CLIO R3T
TROPHY

CLIO R3T

REFERENCE	BULLETIN TECHNIQUE N°15 / TECHNICAL NEWS N°15
DATE	27/05/2015
SUBJECT	Pédale Embayage / Clutch Pedal
PART

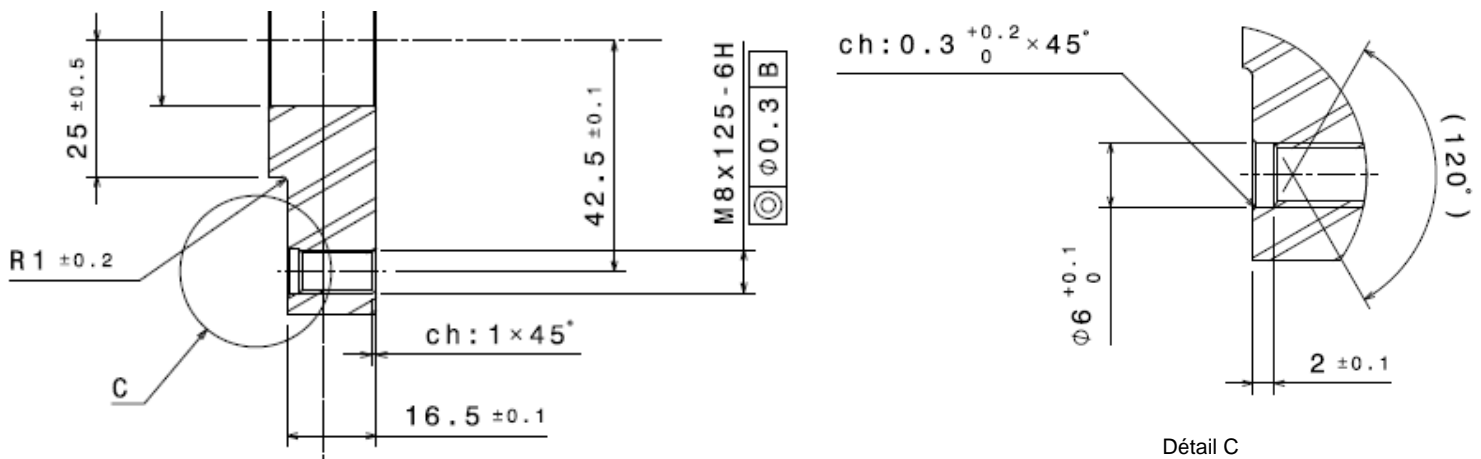
Suite à une remontée client sur la rupture de la rotule liant la pédale d'embrayage à l'émetteur, une évolution est souhaitable sur la pédale d'embrayage.

Following customer information regarding a failure on the ball joint between the clutch pedal and the clutch master cylinder, an evolution is available.

- Remplacer la rotule M6 par une rotule M8 référencée : 82 00 719 623

- Lamage de 3.5mm (côte de 16.5mm) sur la face rotule
- Perçage et taraude M8x125 avec un lamage d'entrée (détail C)

- Replace the M6 ball joint by a M8 : reference 82 00 719 623

- Machining by 3.5mm (16.5 mm on the drawing) on the ball joint surface
- Drill and thread M8x125 (detail C)
